# **MONITORING YEAR 0 ANNUAL REPORT FINAL - REVISED**

## **OAK HILL DAIRY MITIGATION SITE**

RE: Oak Hill Dairy Final Revised 2023 MY0 Report Review  
Catawba River Basin – CU# 03050102 – Gaston County  
DMS Project ID No. 100120  
Contract # 7867

The Division of Mitigation Services (DMS) received the Draft Mitigation Plan for Oak Hill Dairy from Wildlands Engineering, Inc on May 23, 2022. The Project is expected to provide 4,618.933 SMUs and 7.680 WMUs. The following are the DMS review team's comments on the draft report.

Figure 1a. Current Condition Plan View  
 Oak Hill Dairy Mitigation Site  
 DMS Project No. 100120  
 Monitoring Year 0 - 2023

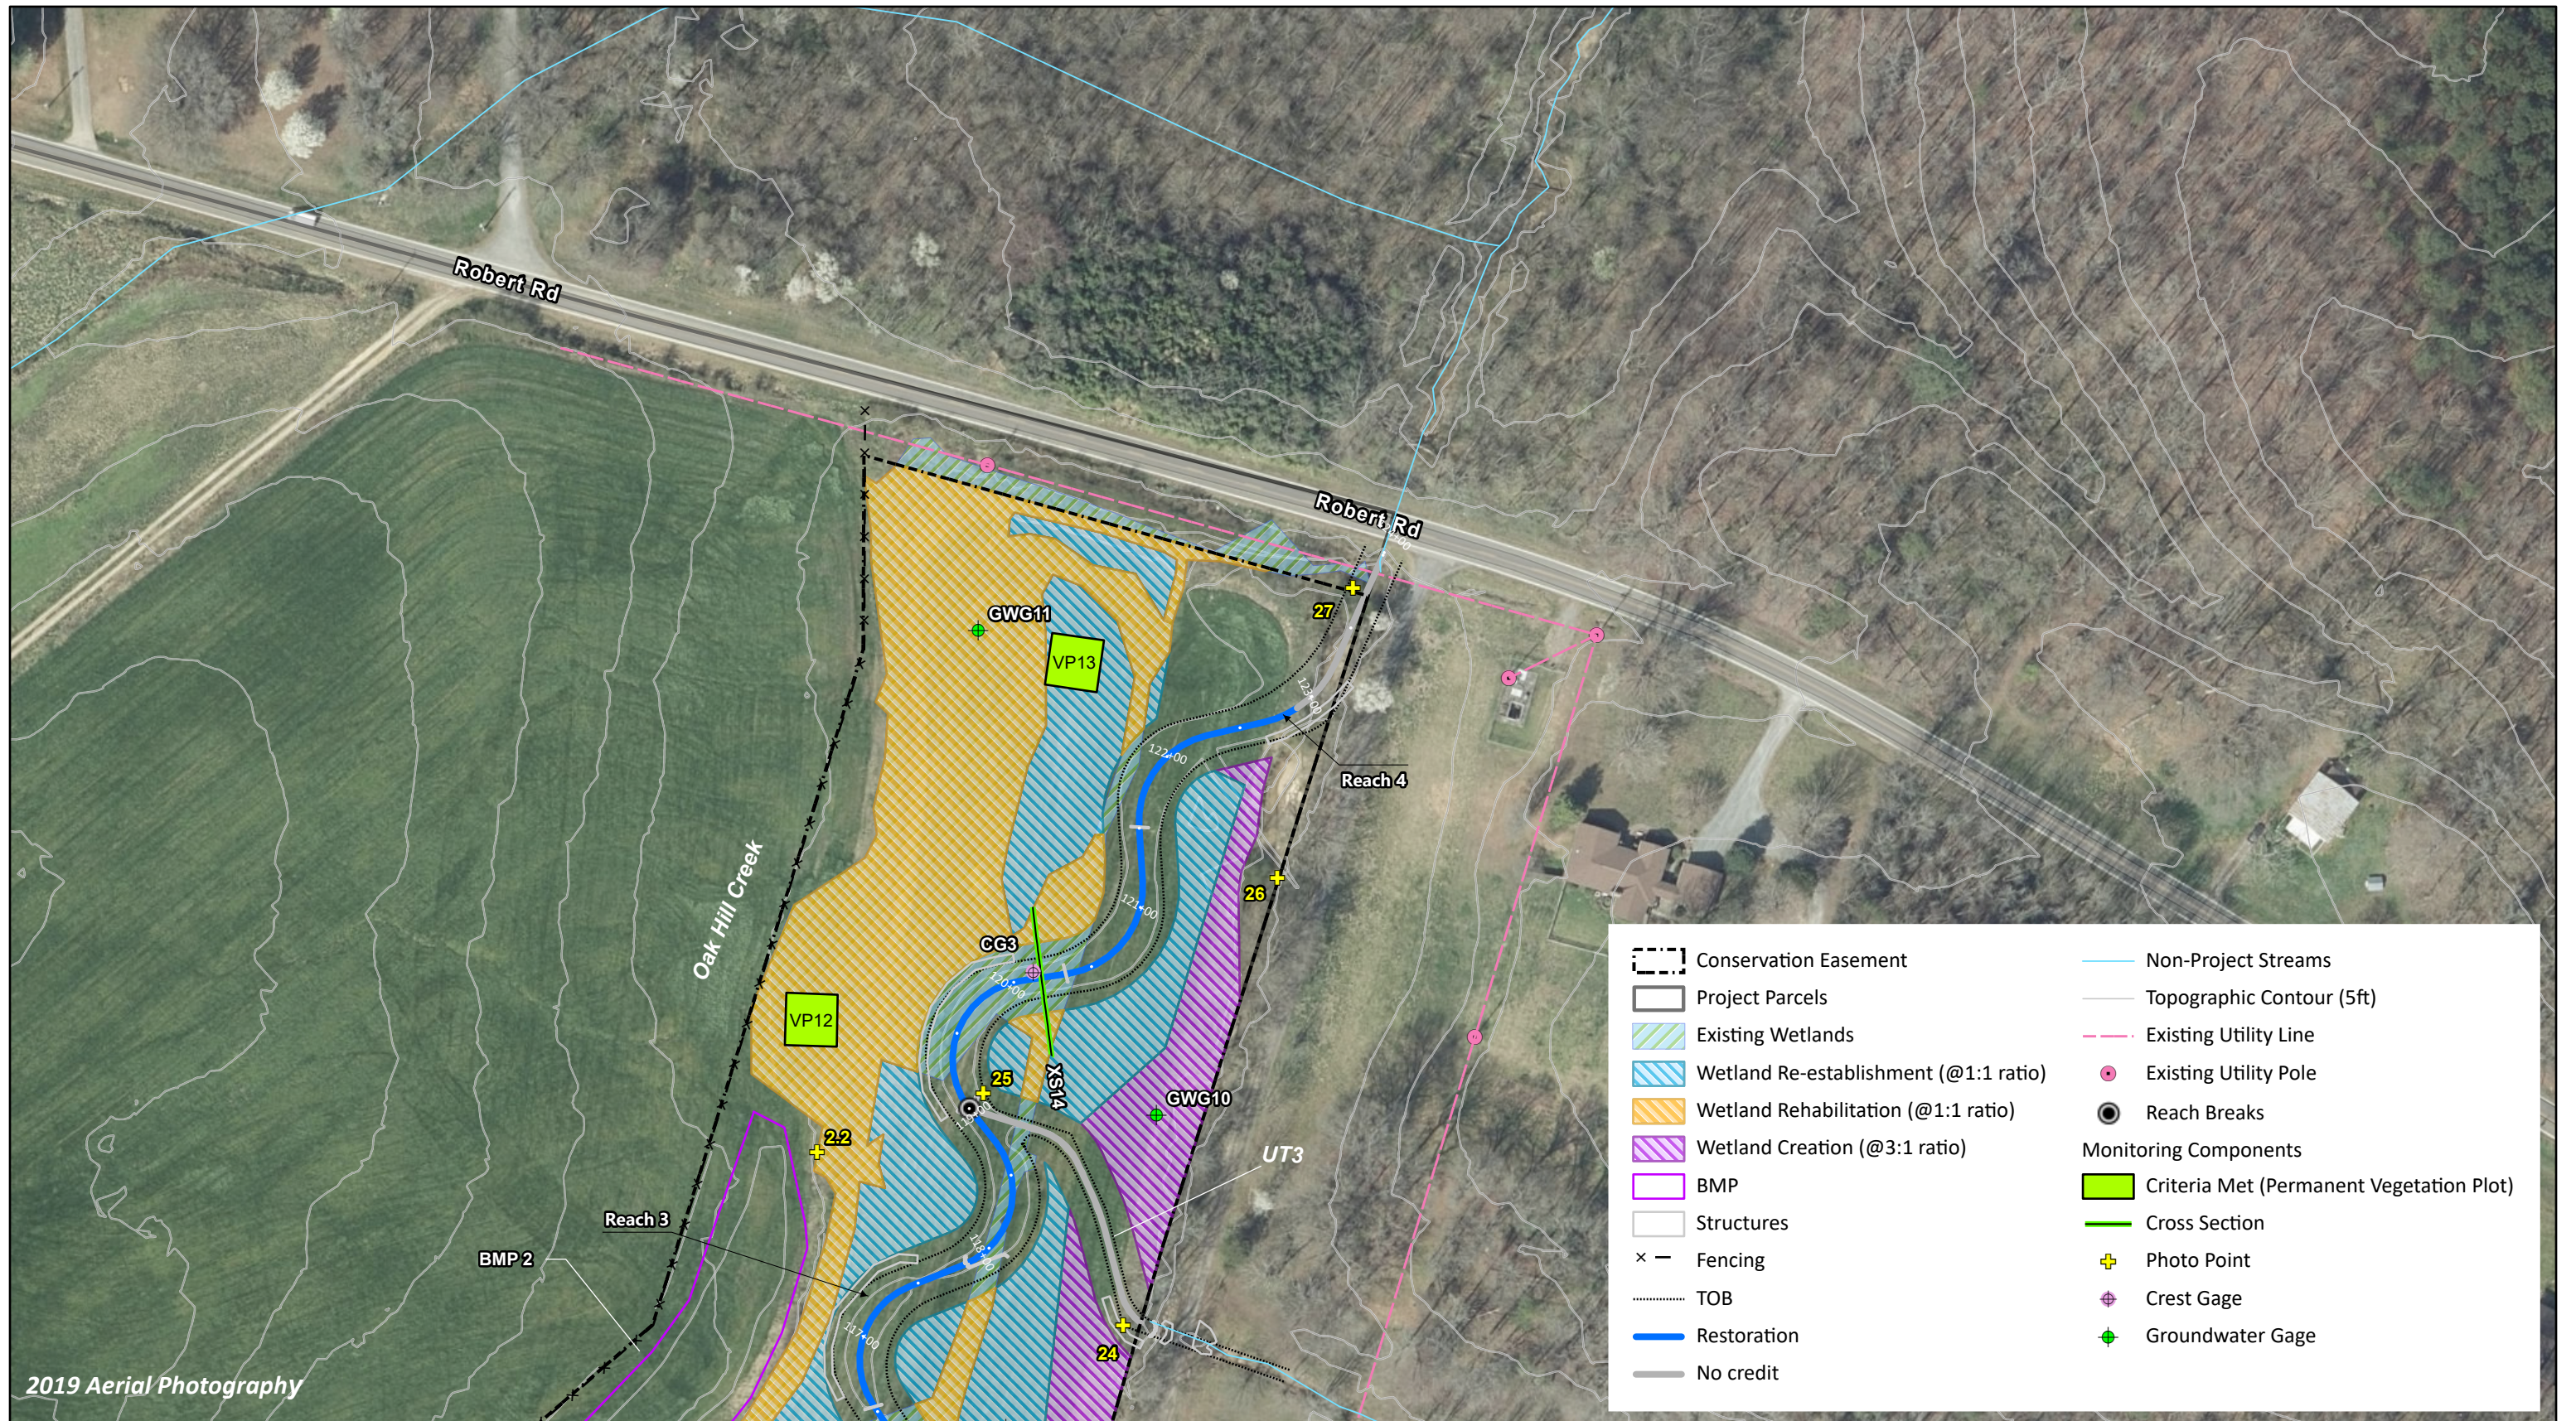
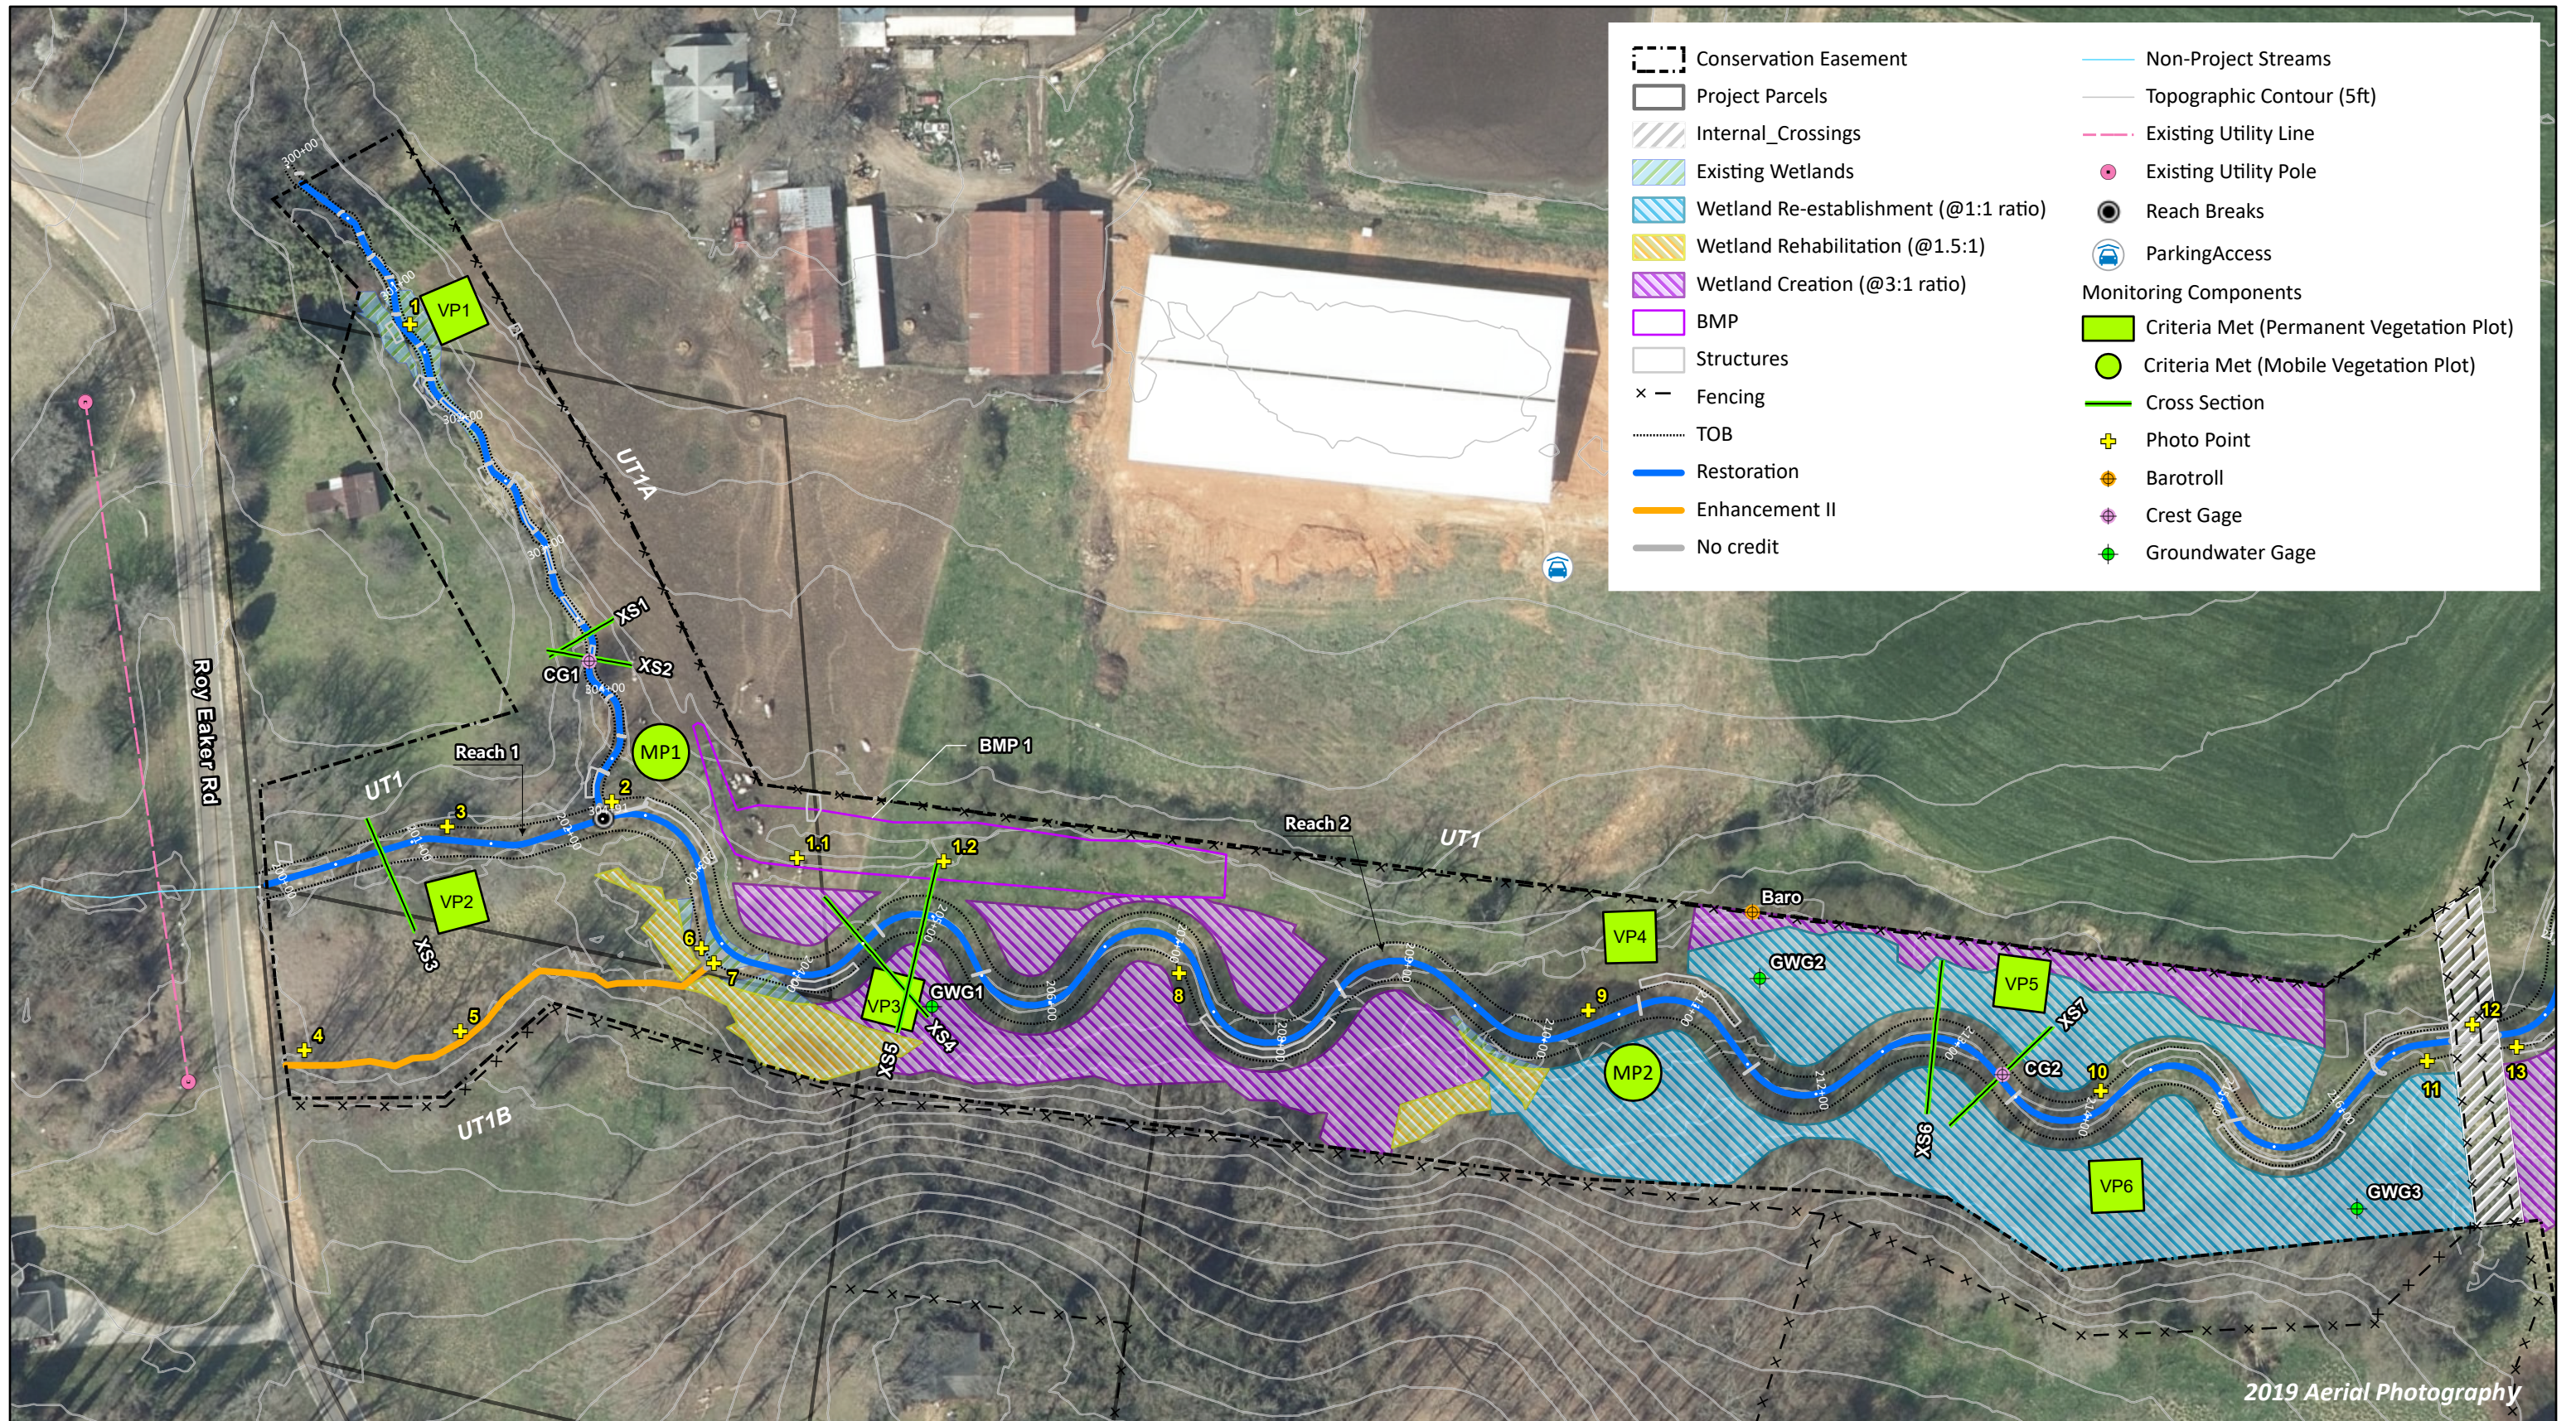
- CCPV: Recommend labeling BMP1 and BMP2.
- Photos of BMP1 and BMP2 show a considerable amount of ponded water. Does WEI expect the BMPs to hold water year-round or dry seasonally?

**Wildlands Response:** BMP labels are now shown on CCPV maps.

**1.14**

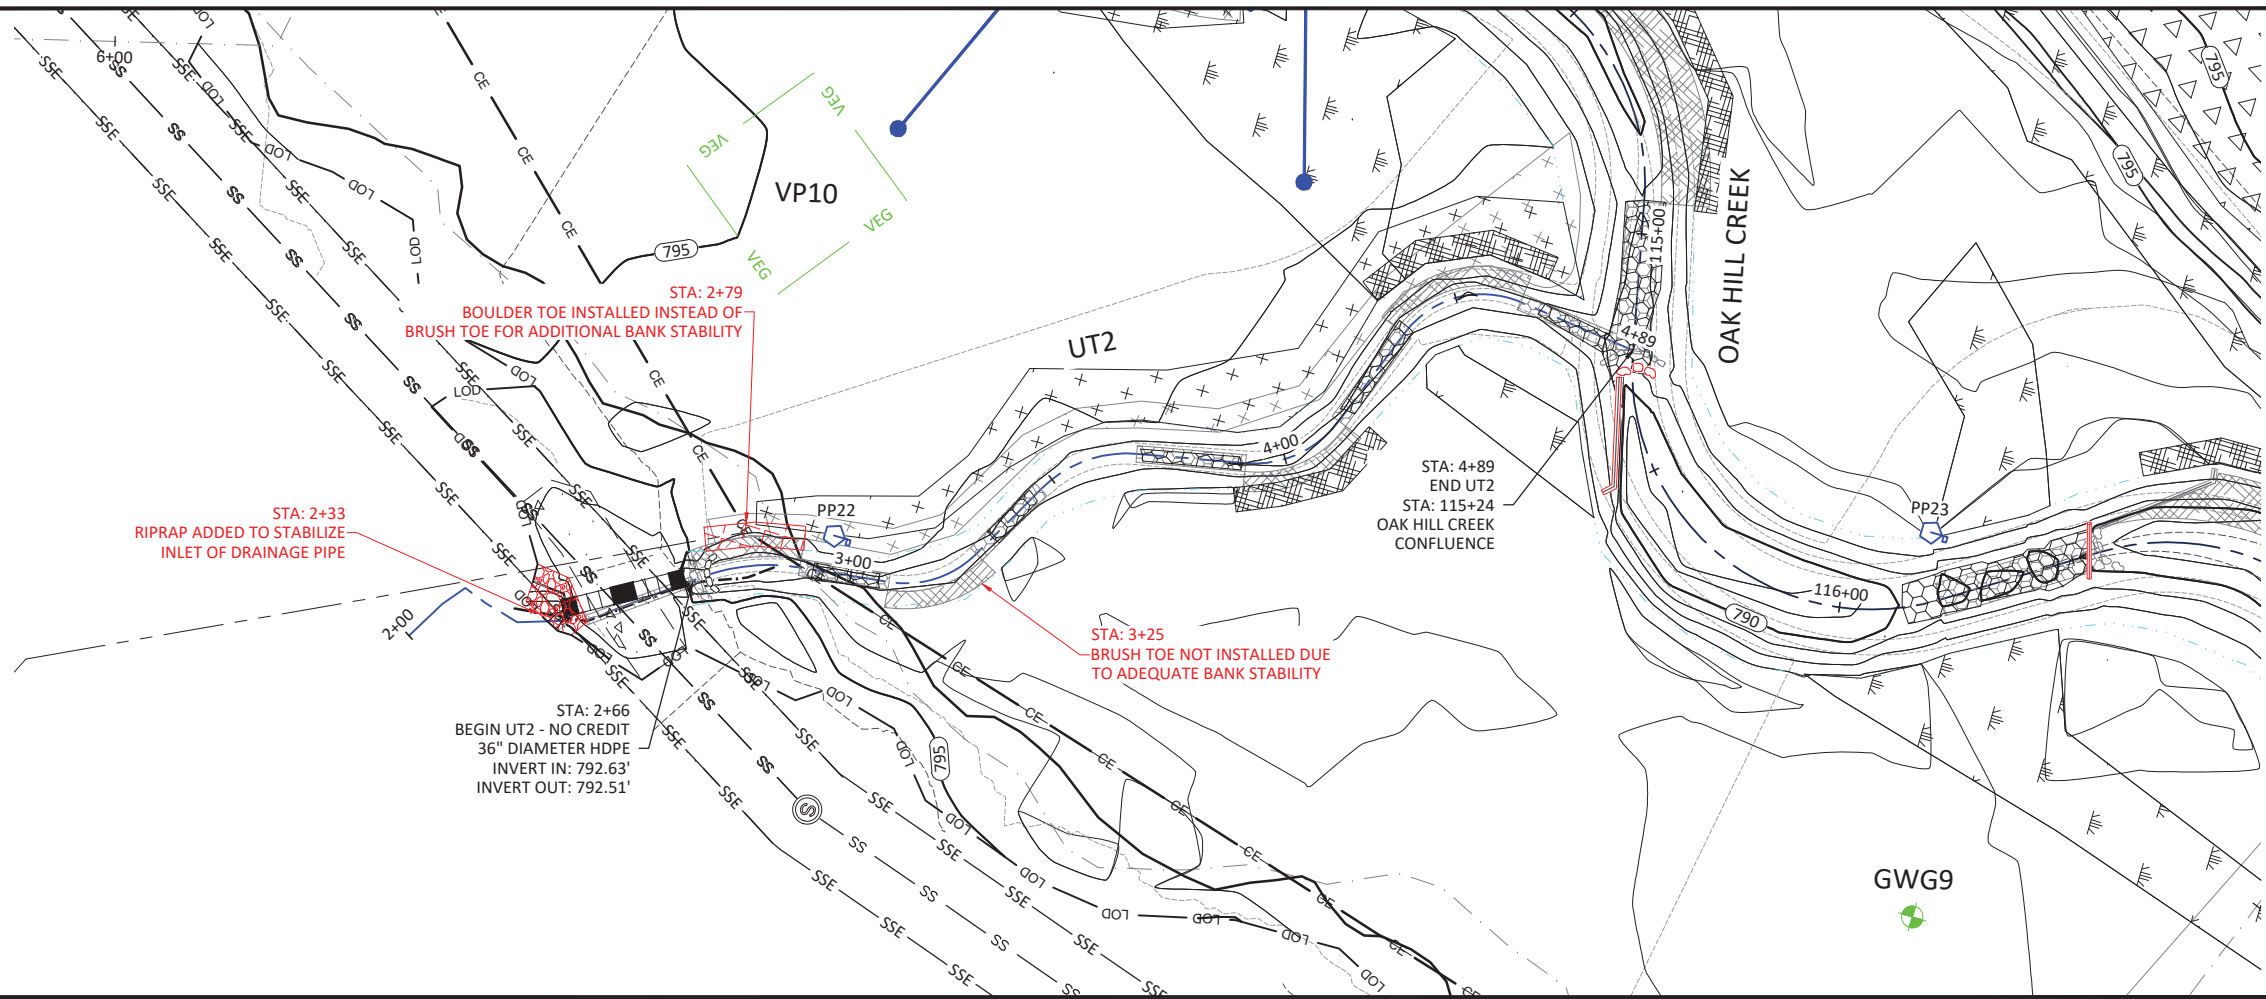
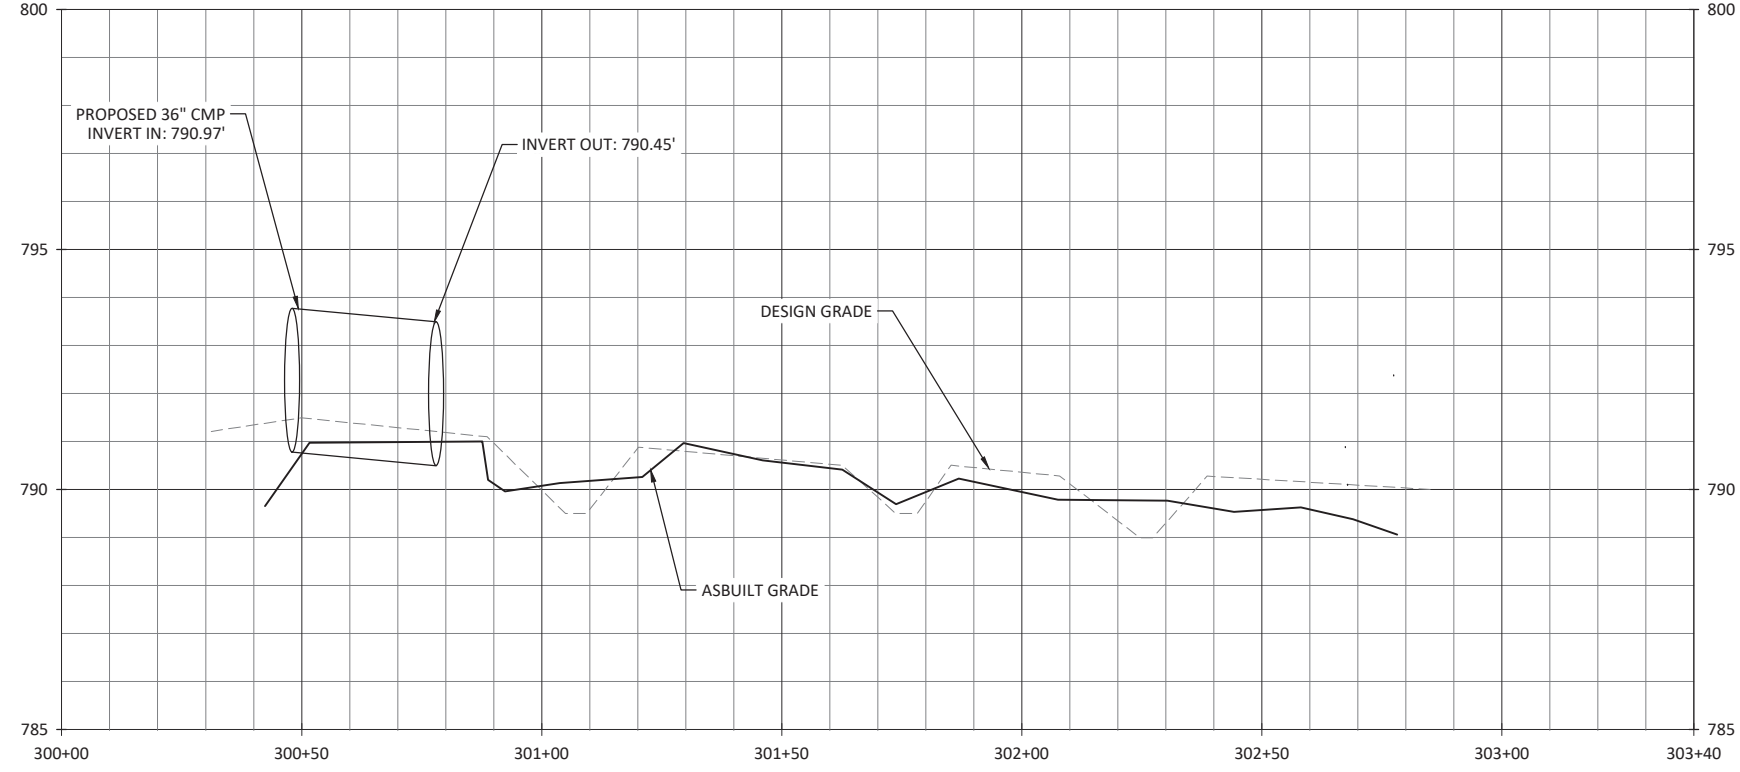
7. *Sheet 1.14: Pools on UT2 profile are shown and noted as being filled with sediment. WEI expects the pools to adjust as vegetation becomes established. Please provide an update in MY1 regarding the UT2 stream conditions. Note that UT2 is not a credited reach.*

**Wildlands Response:** A brief summation of UT2 stream conditions will be included in MY1.
